Re: WBI Energy Transmission, Inc.
North Bakken Expansion Project
Docket Nos. CP20-52-000 and CP20-52-001
Variance Requests for Project Modifications

Pursuant to Environmental Condition No. 5 of the Order, WBI Energy hereby submits Level 3 variance requests for certain Project modifications that include:

North Bakken Expansion Project Variance Request Form

Variance Request Number: V21

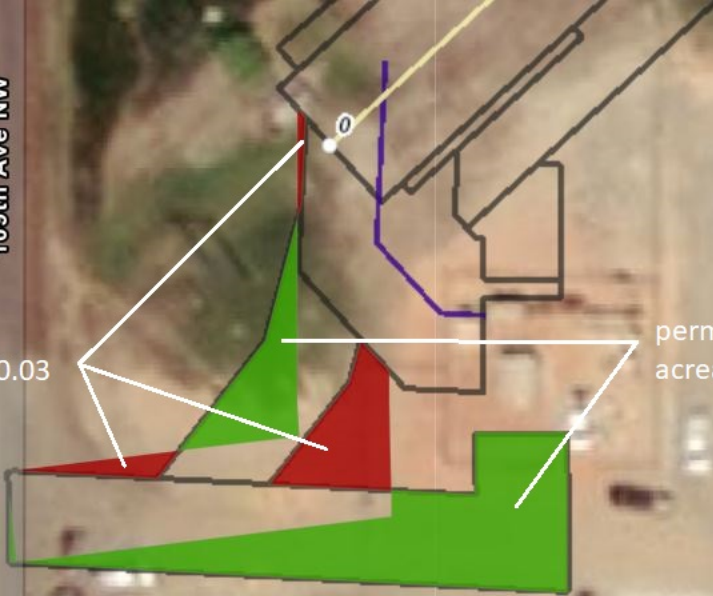
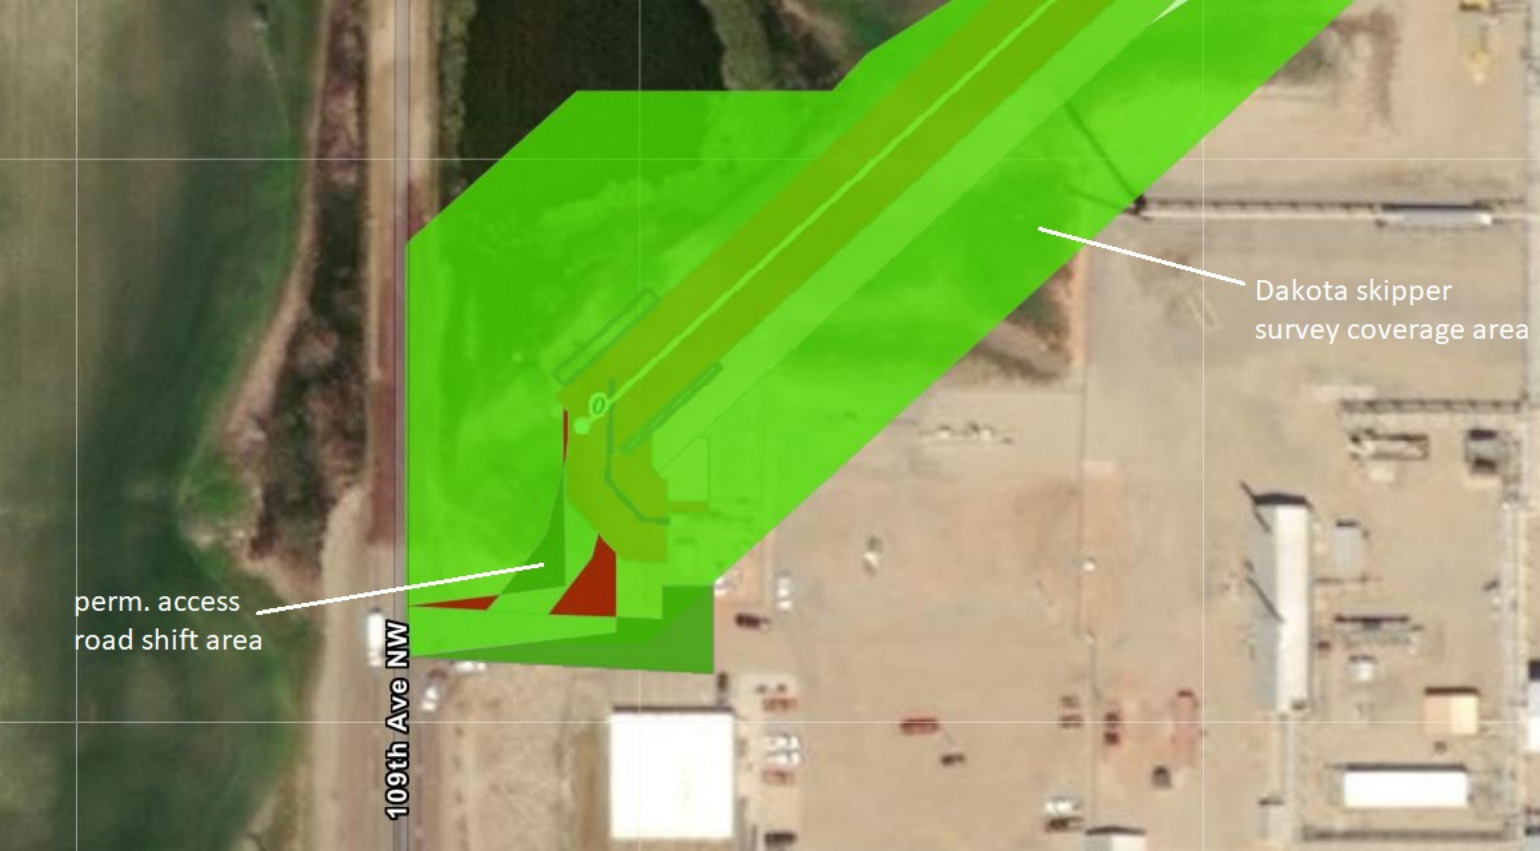
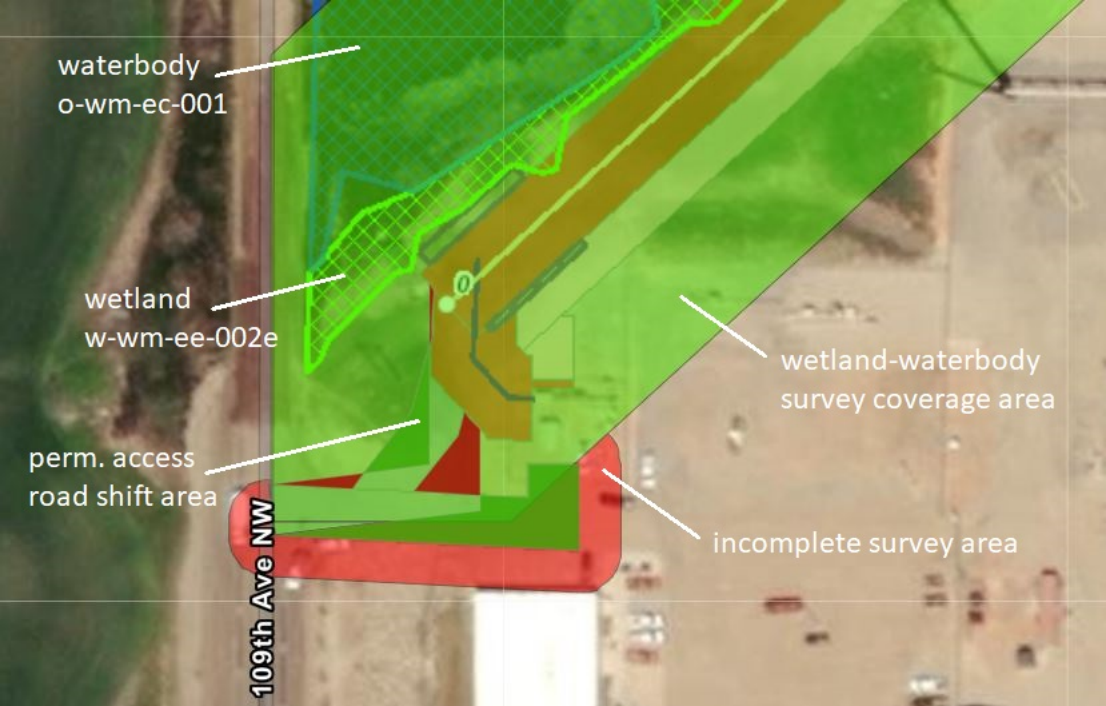
The permanent access road needs to be shifted to the northwest and southeast. A portion of the road footprint will remain in the original, permitted location. Total acreage affected is as follows: 0.11 permanent access road addition, and 0.03 permanent access road removal. Best management practices will be implemented as necessary to protect the wetland.

Landowner has improved the site in order to implement additional security features within the footprint of the original proposed permanent access road. The permanent access road requires shifting to avoid impacting the new plant card reader and its adjoined access point.

Variance Request Number: V25

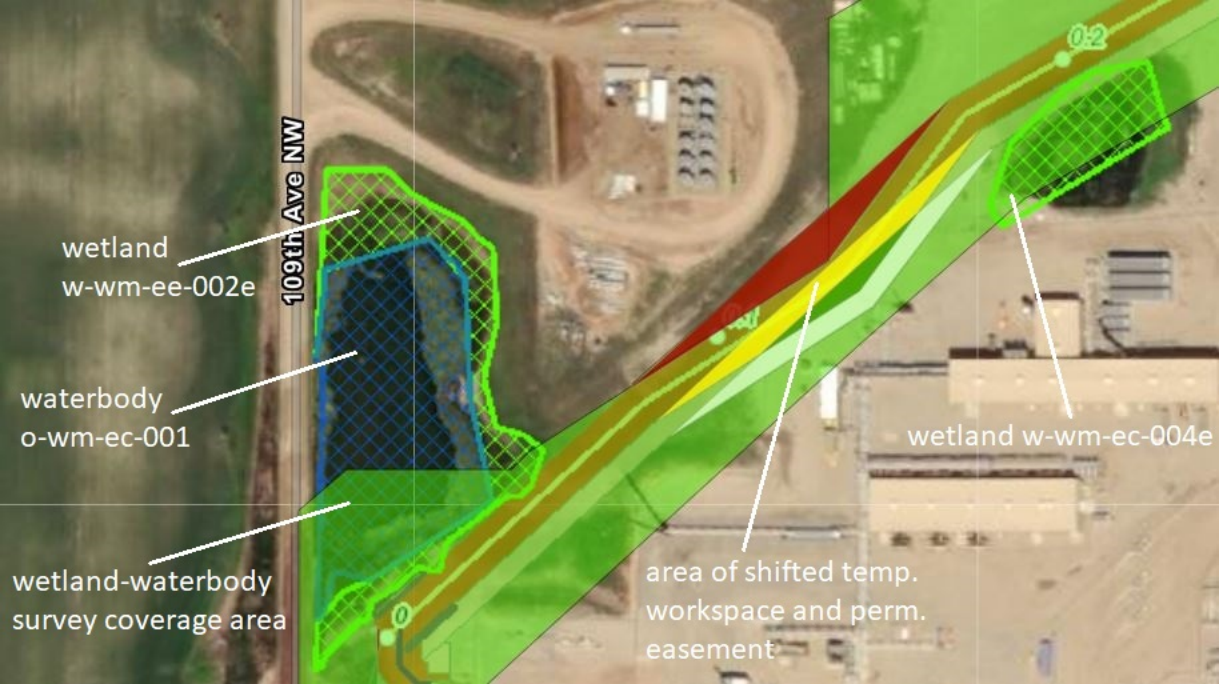
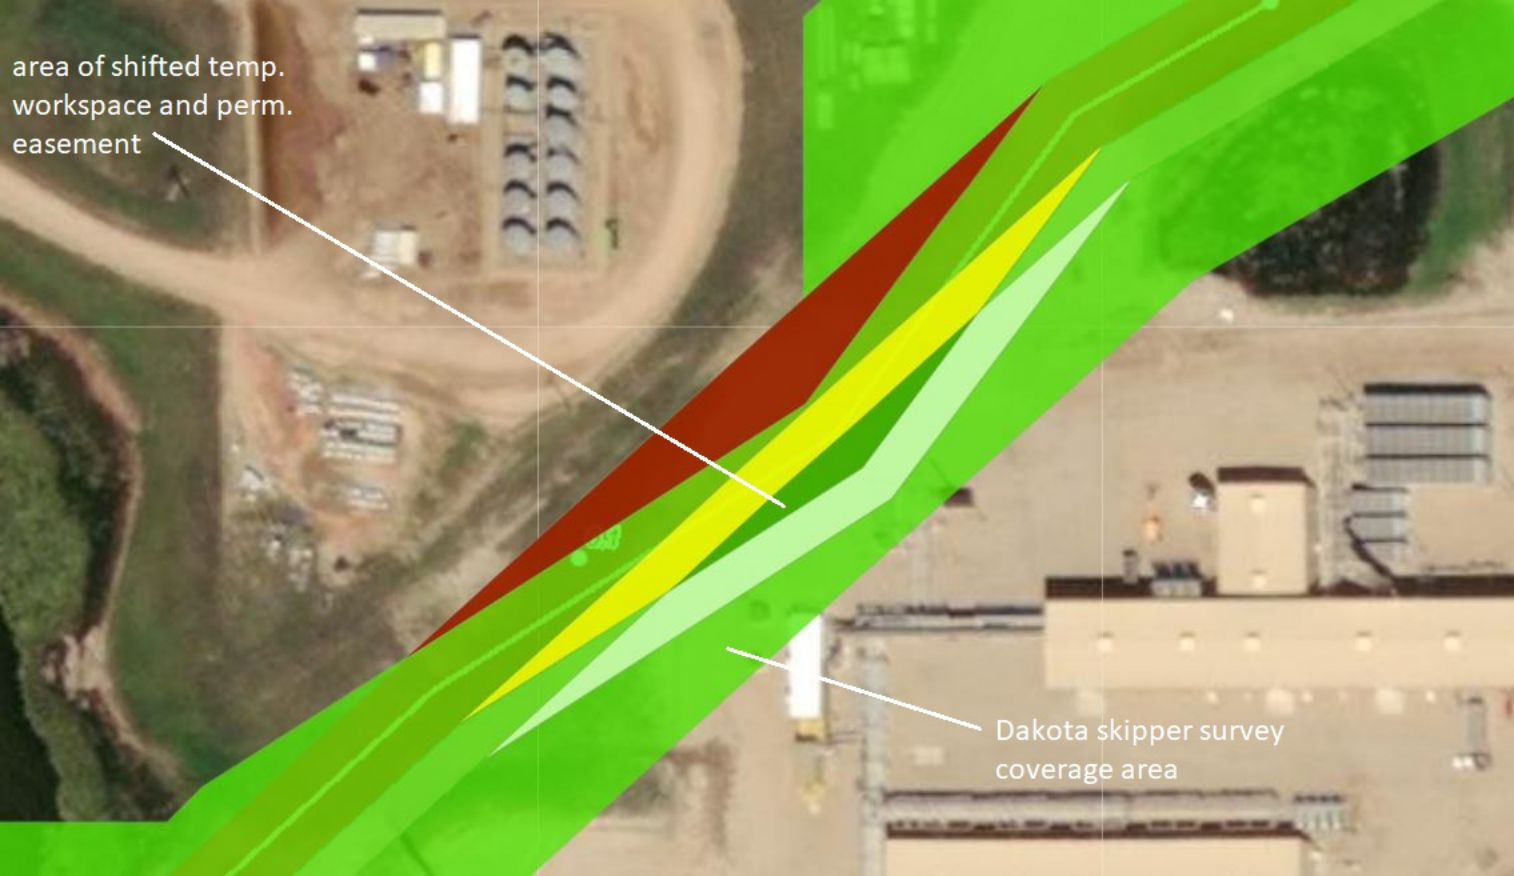
The permanent easement and temporary workspace requires shifting to the southeast. Total acreage affected is as follows: 0.06 permanent easement addition, 0.27 permanent easement removal, 0.22 temporary workspace addition, and 0.22 converted from temporary workspace to permanent easement.

This reroute has been requested by the landowner to minimize potential impacts on future plans for the property.
